No.	Date	Description
1	2025-09-19	Add No. 1
2	2025-09-30	Add No. 2

**WCFPD Station 3**  
**Wright City Fire Protection District**  
9 Highway WW  
Wright City, MO 63390

EXTERIOR ELEVATIONS

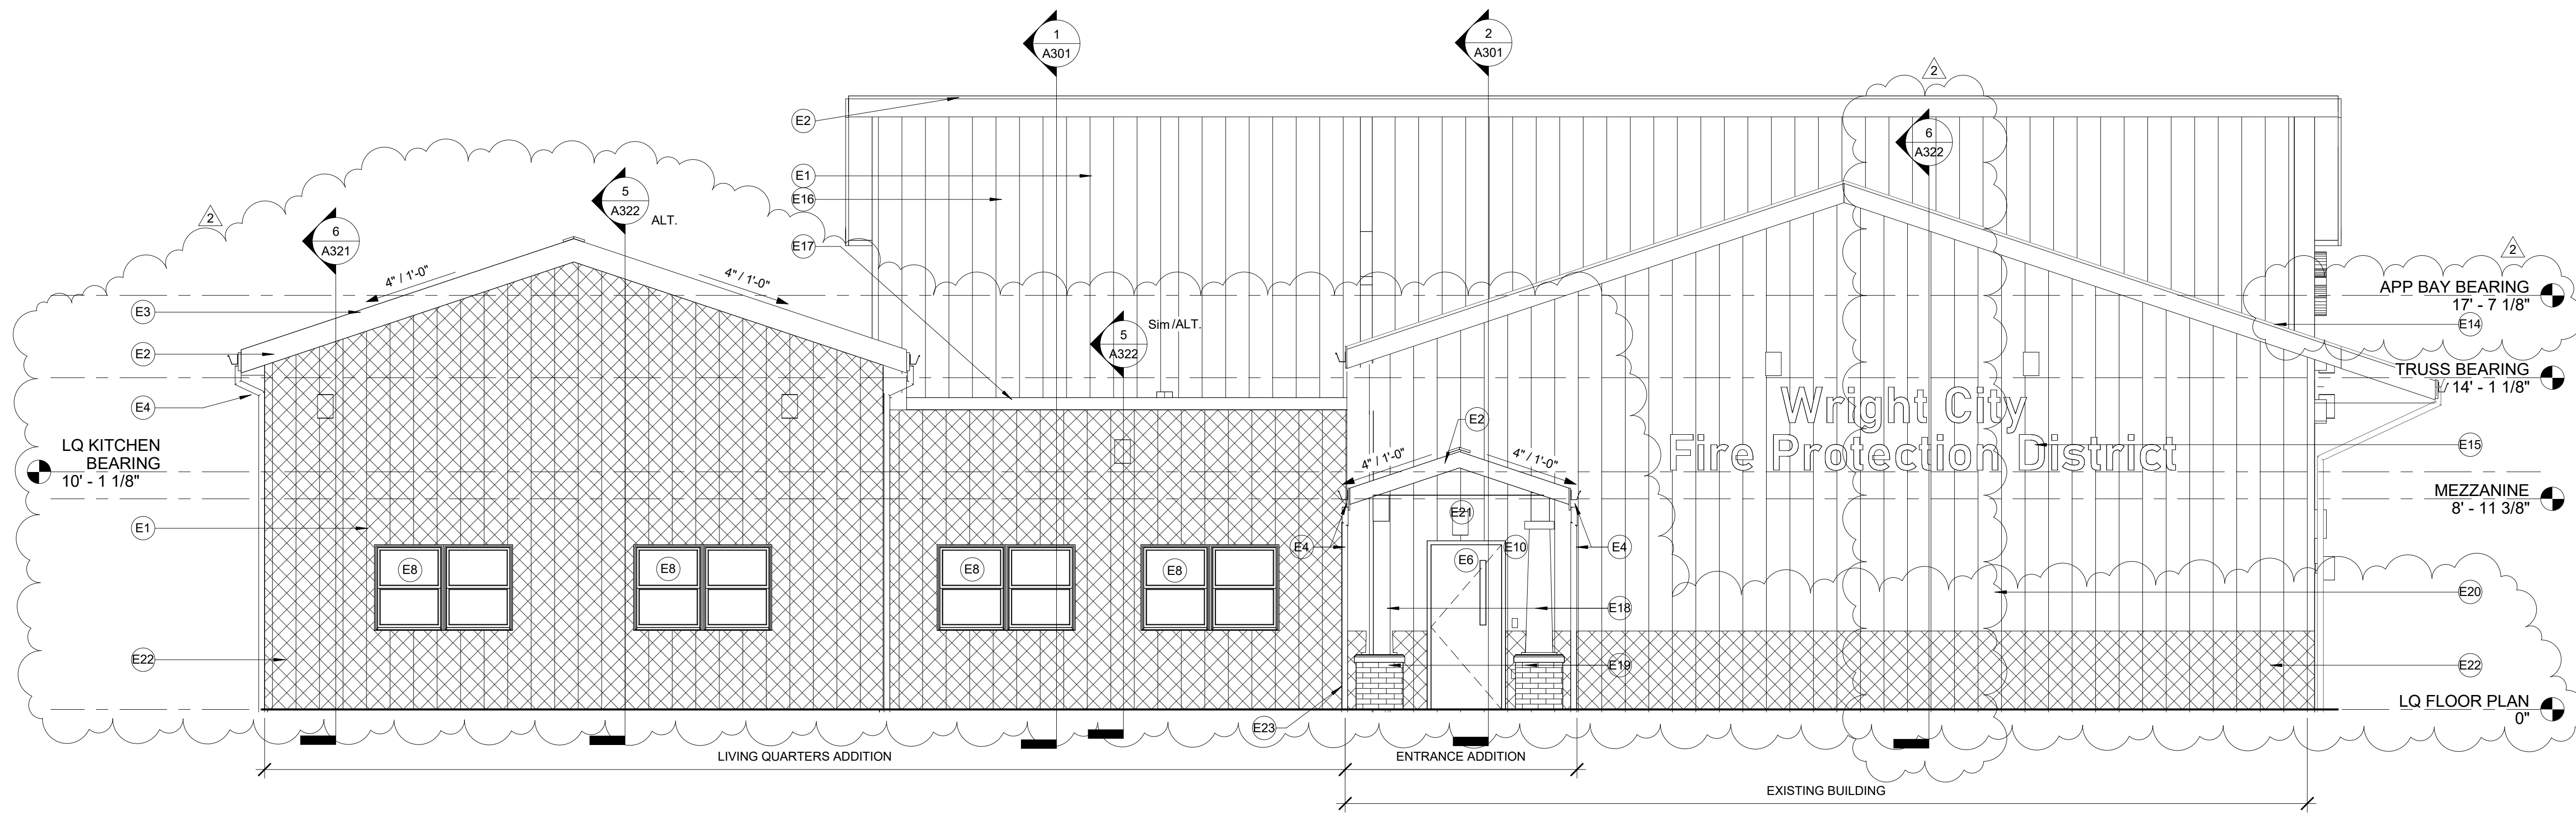
- g. ADD and expansion joint between the existing and new buildings (Keyed Note E23).
- 20) Sheet A202 – EXTERIOR ELEVATIONS
- a. REVISE Keyed Note E1.

- b. ADD Keyed Note E21 and note on the elevation.
  - c. ADD various notations to the elevation.
  - d. ADD Keyed Notes E21, E22 and E23.
  - e. REVISE the App Bay Bearing Height to 17' – 7 1/8" to match structural.

- f. REVISE the windows to be taller.
  - g. ADD hatch to the elevation to show where the alternate for brick veneer or thin brick is located. Refer to the floor plan and wall sections 5/A322 and 6/A322.

- h. ADD and expansion joint between the existing and new buildings (Keyed Note E23).
- 21) Sheet A221 – INTERIOR ELEVATIONS
- a. MODIFY interior elevation general notes.

**1 BUILDING SECTION 1**  
A301 1/4" = 1'-0"

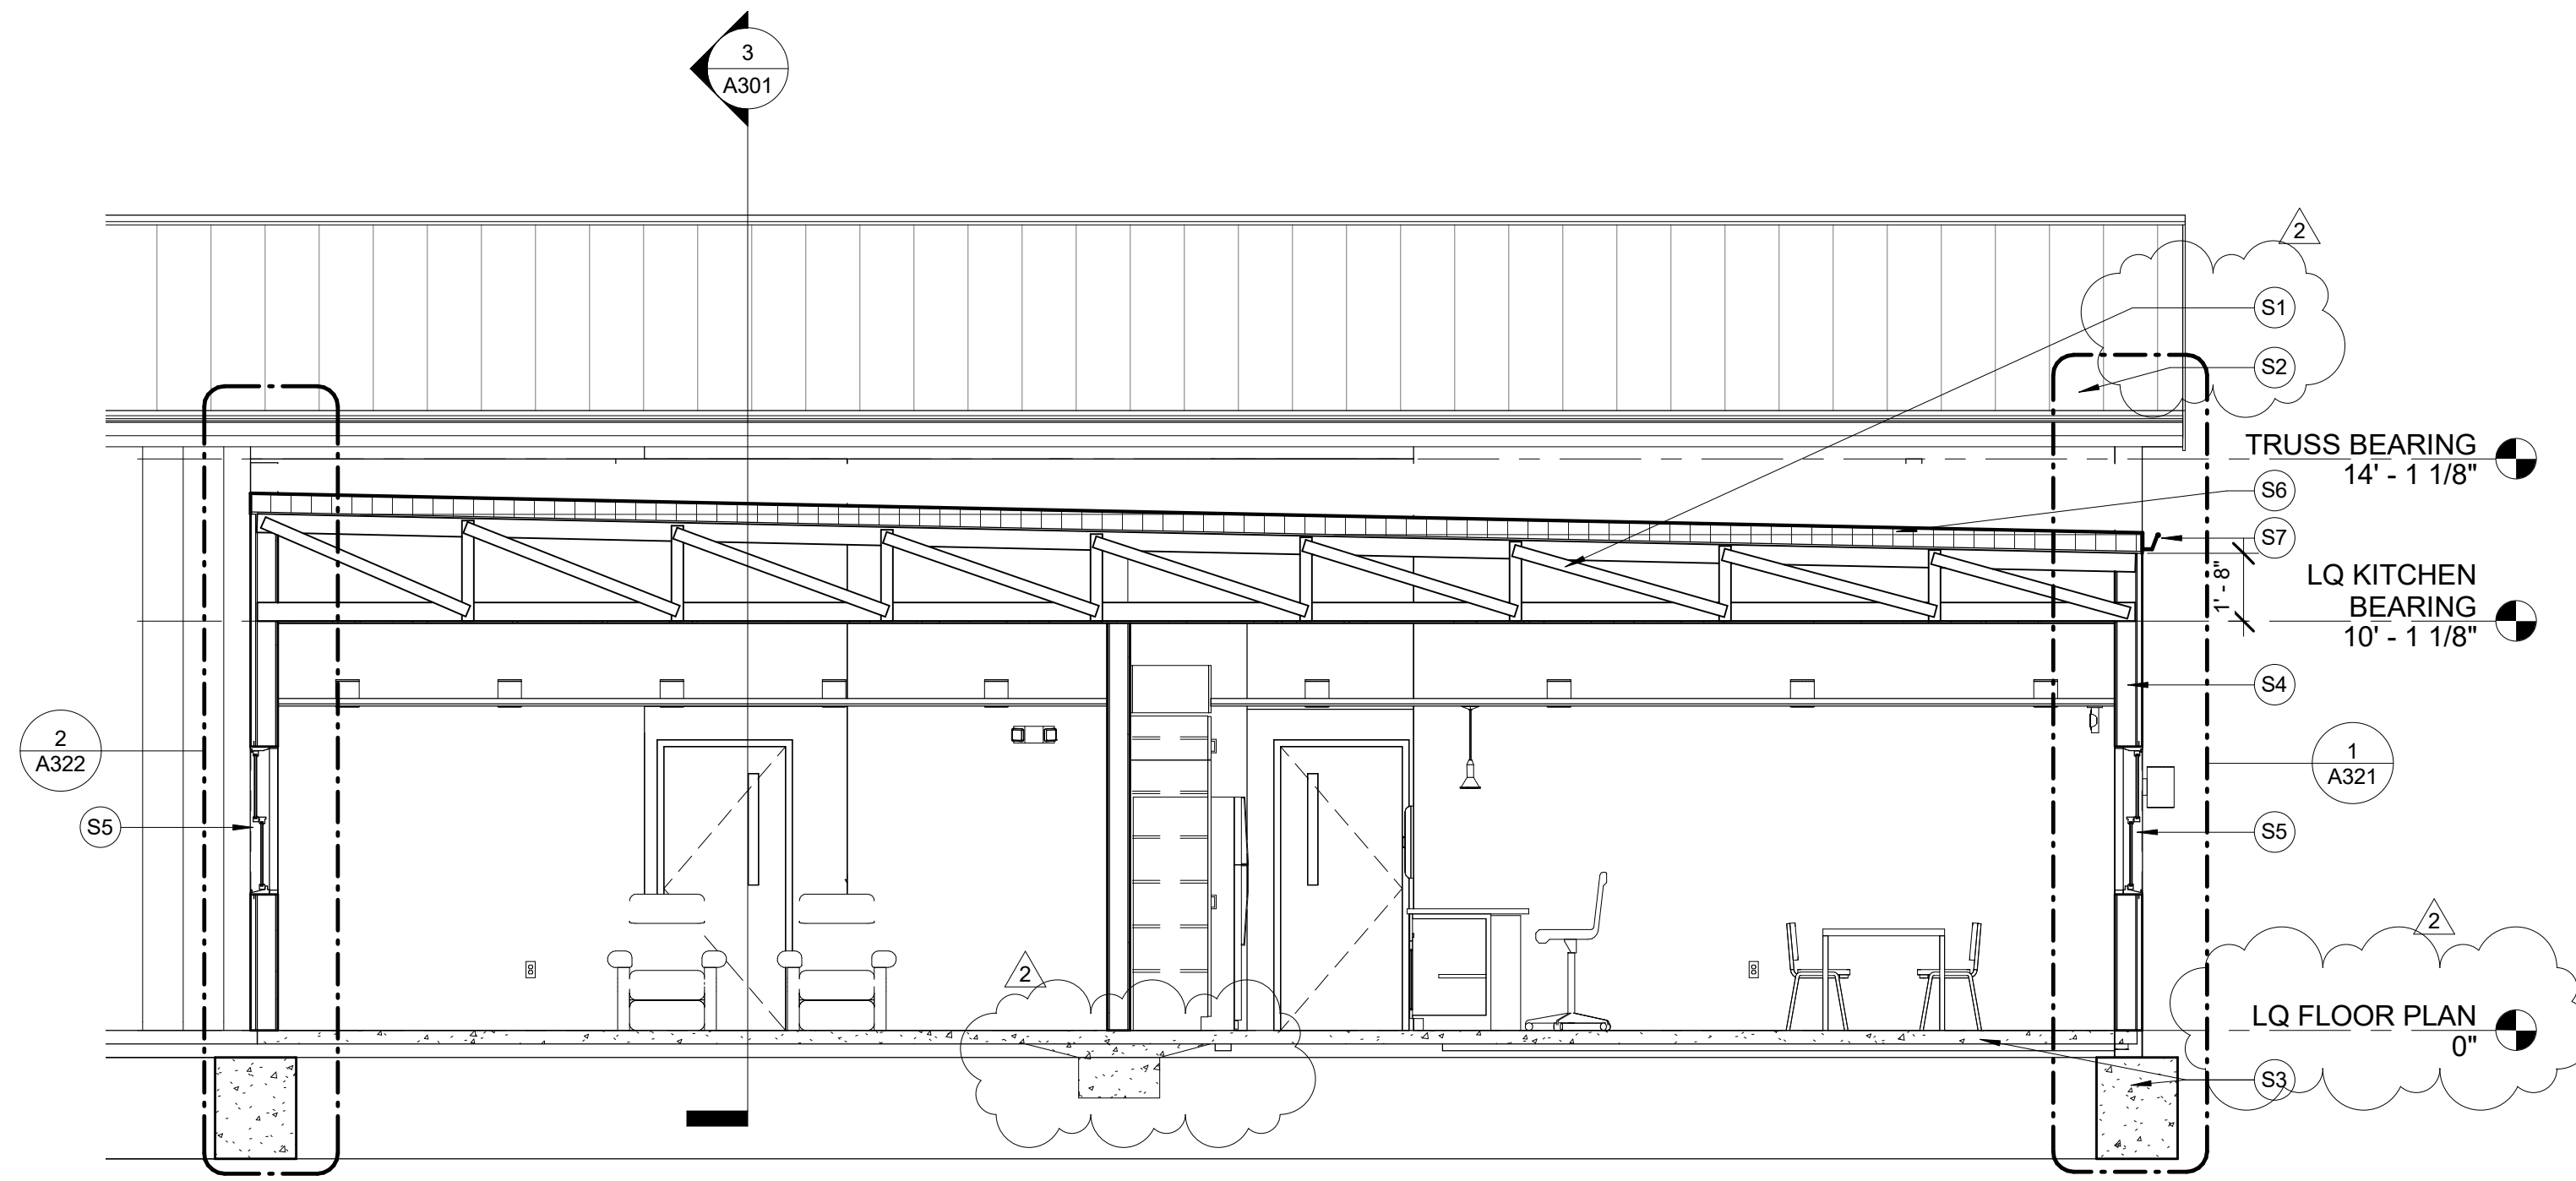
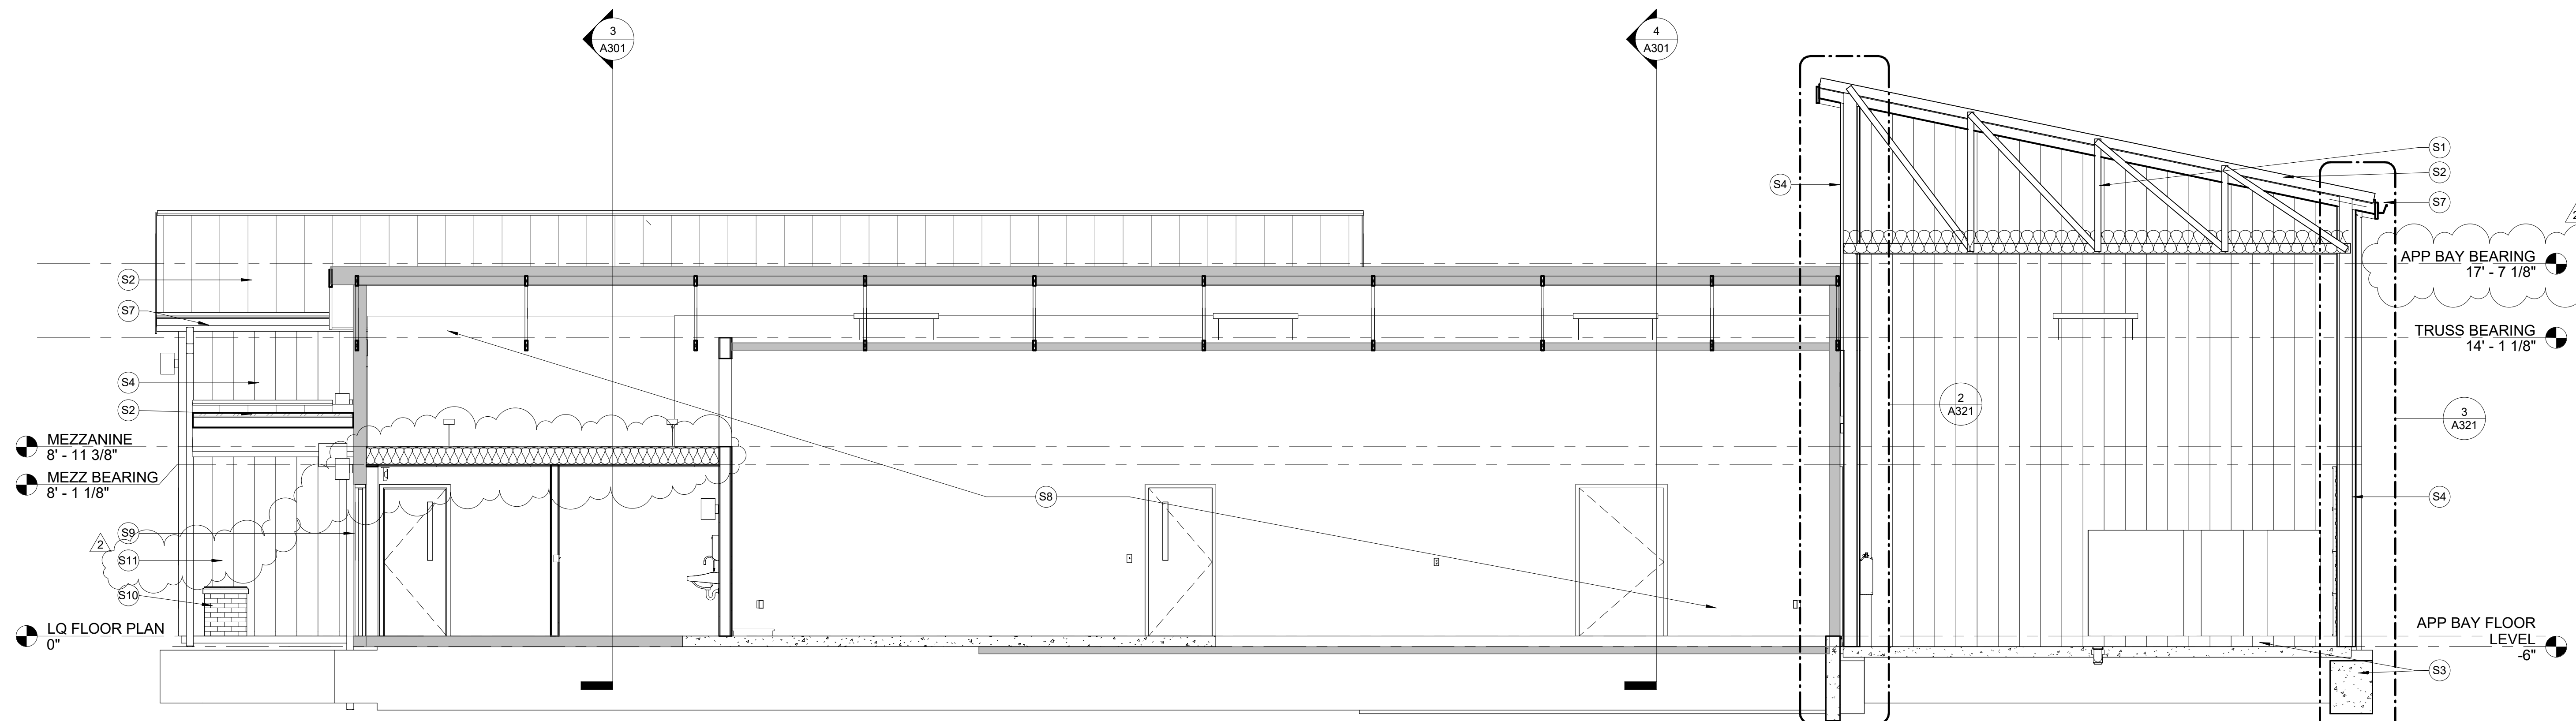
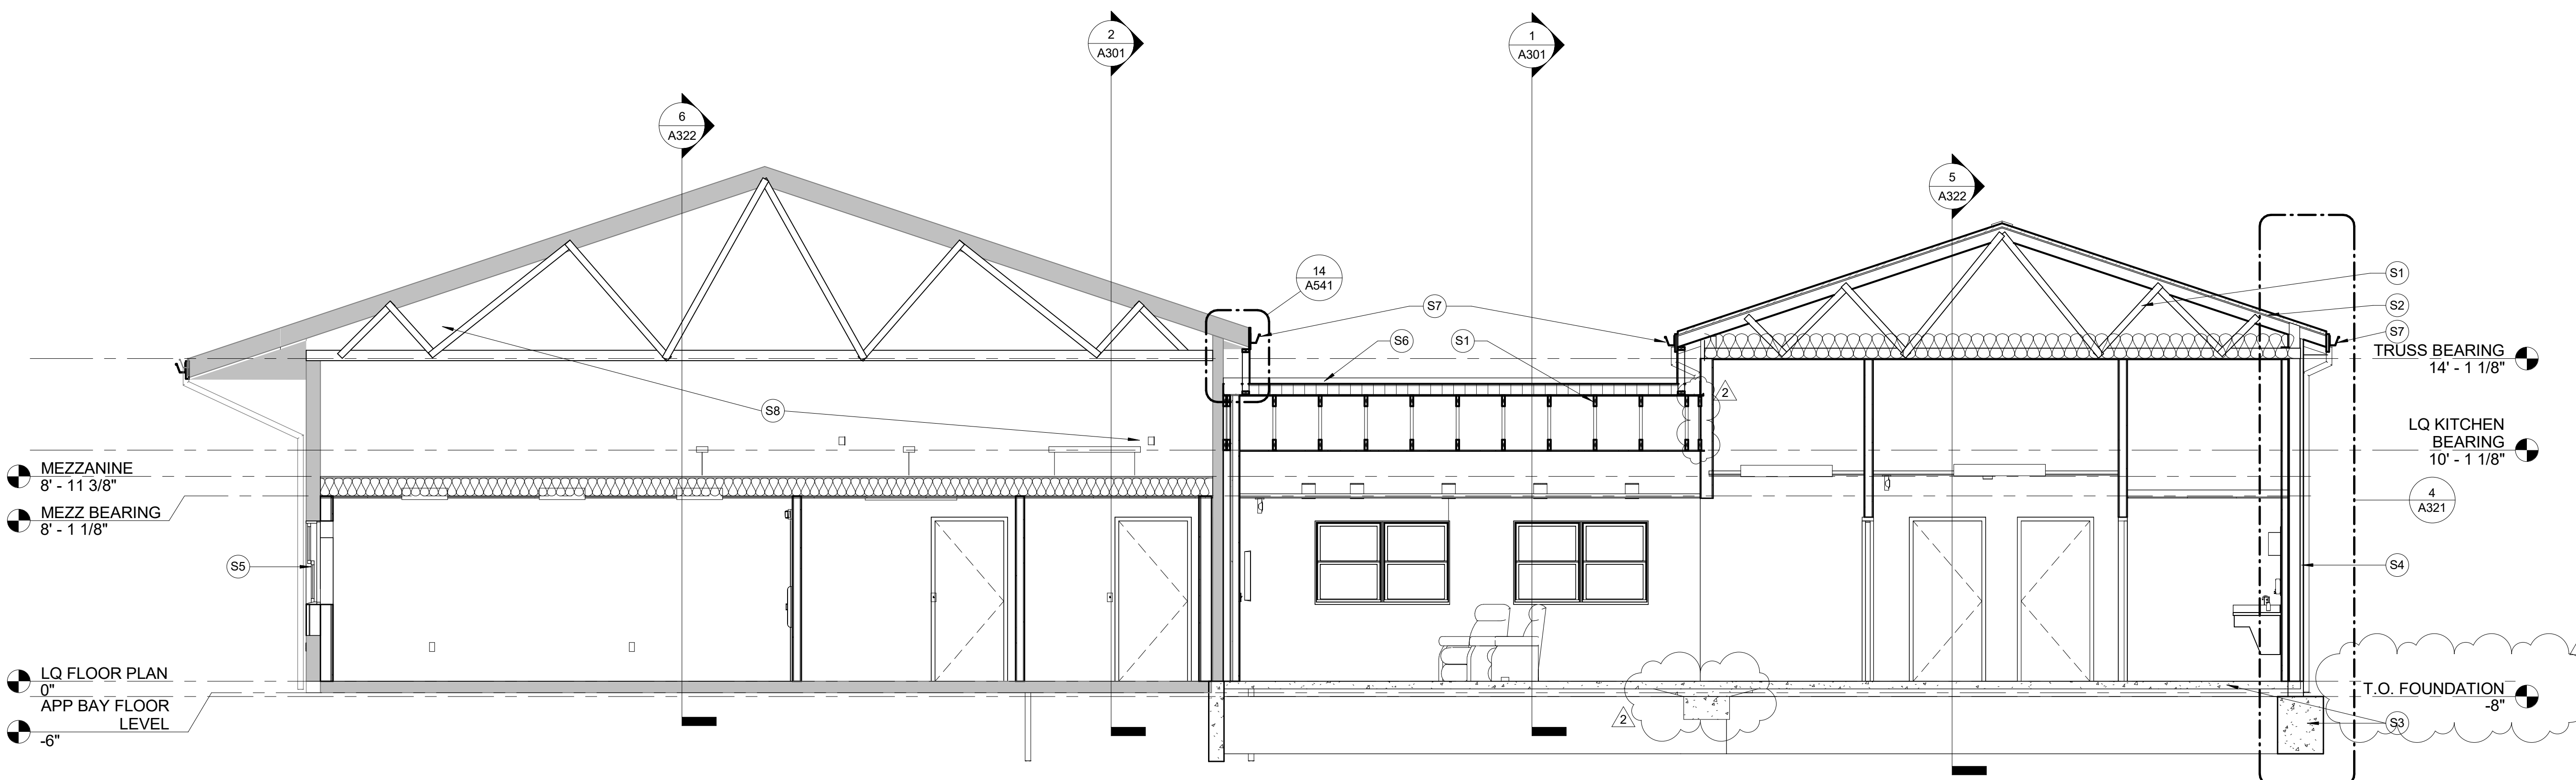
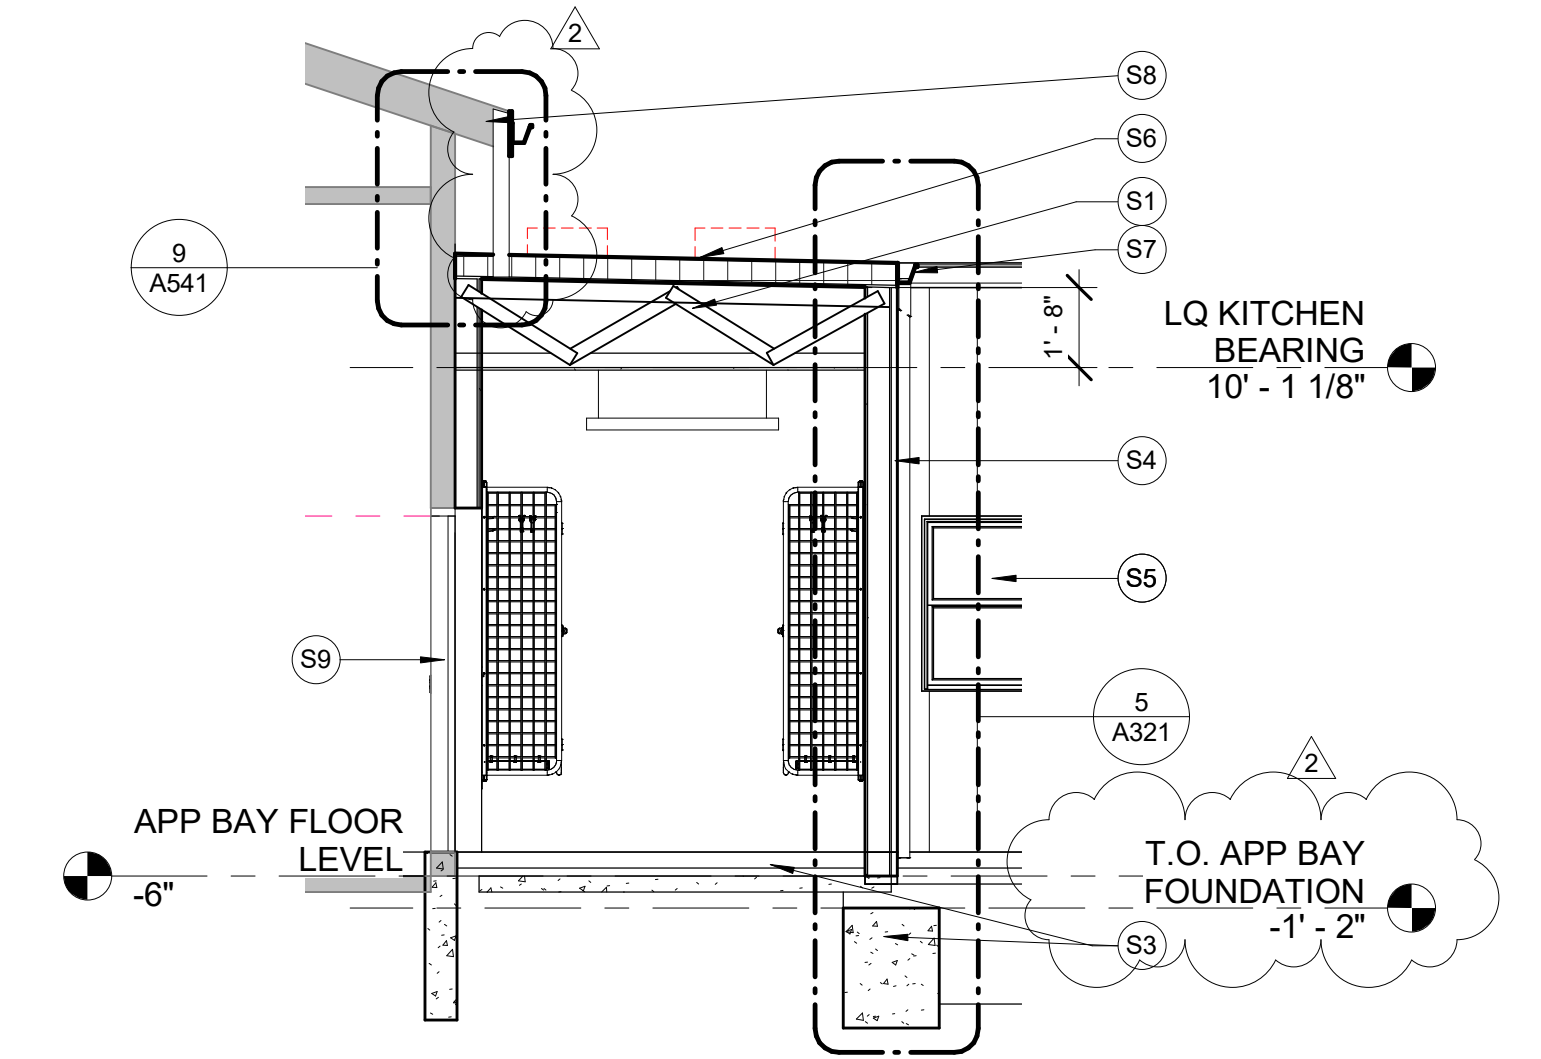
- c. REVISE interior elevations.
- 22) Sheet A301 – BUILDING SECTIONS
  - a. REVISE Keyed Note S4.
  - b. ADD Keyed Note S11.
  - c. REVISE building sections.
